County of Fairfax, Virginia

STAFF REPORT

APPLICATIONS RZ/FDP 2012-MV-007
Waiver #5224-WPFM-001-1

APPLICANT: Bainbridge Communities Acquisition III, LLC

CONCEPTUAL LANDSCAPE PLAN

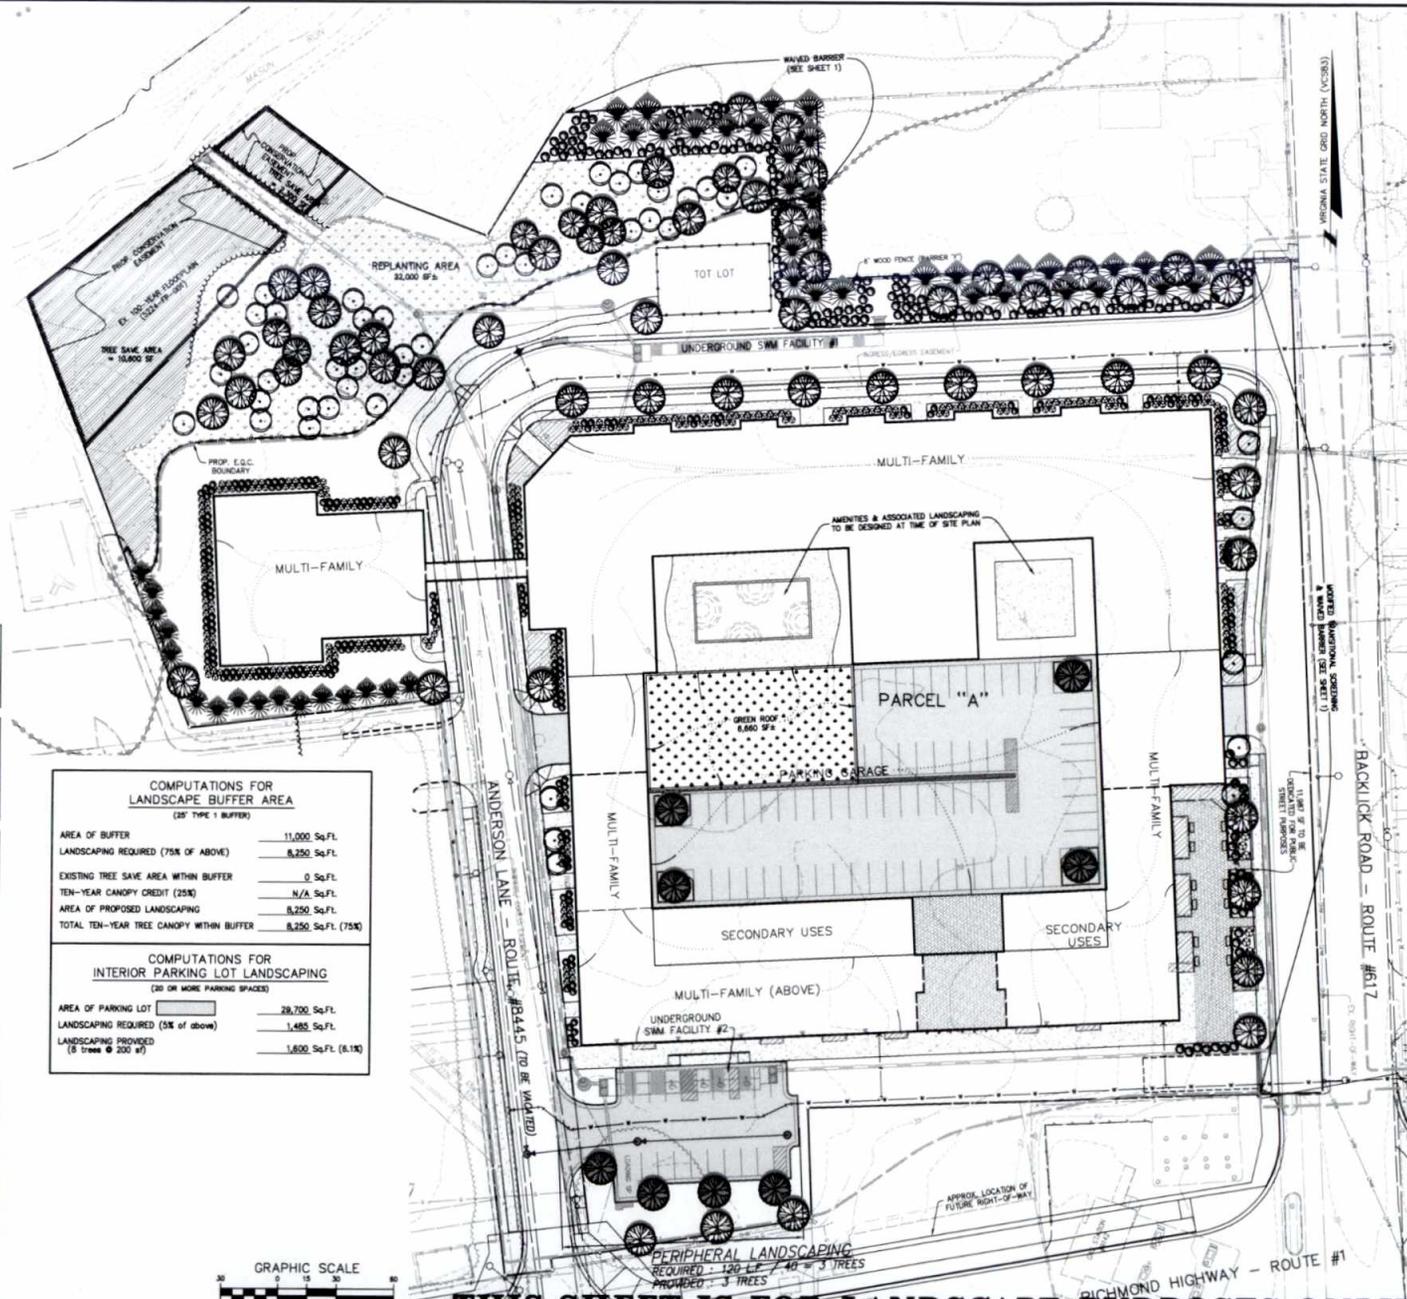
2.Comment: The transitional screening required along Backlick Road is reflected in groupings of trees, shrubs and small trees adjacent to walkways for access to the proposed buildings. The layout of this area should be revised to create a larger less fragmented screening-planting area, and to combine some of the walkways to allow for this. Additionally, sheet 6 of the CDP/FDP shows an extension of the parking lot into the screening yard along Backlick Road. The screening proposed is not effective.

OUTFALL NARRATIVE

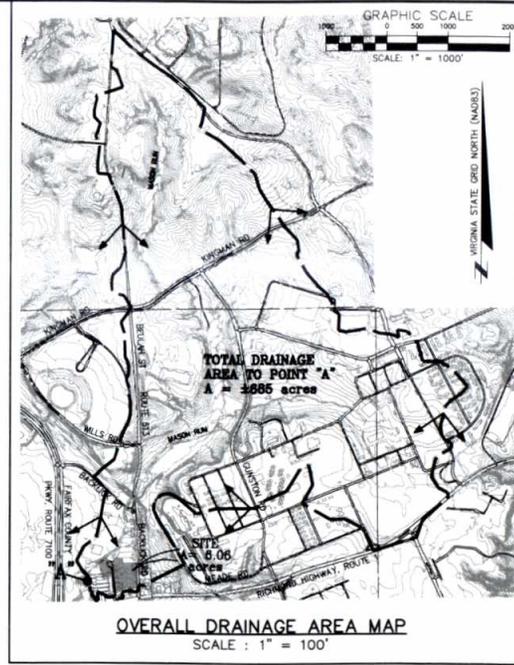
A final floodplain and RPA survey is required to be approved prior to site plan approval. The site is located in the Accotink Creek Watershed and there are no recent downstream drainage complaints on file. The applicant proposes to manage stormwater through underground detention vaults which are depicted on the plat. A waiver of the Public Facilities Manual (PFM) prohibition of underground detention facilities in residential areas is required. The Department of Public Works and Environmental Services (DPWES) review of the requested waiver is detailed under the modifications/waivers section below. Staff notes that a new stormwater management ordinance and updated Public Facilities Manual are being developed as a result of changes to the State code. Depending on when the site plan is approved it may be subject to the new regulations.
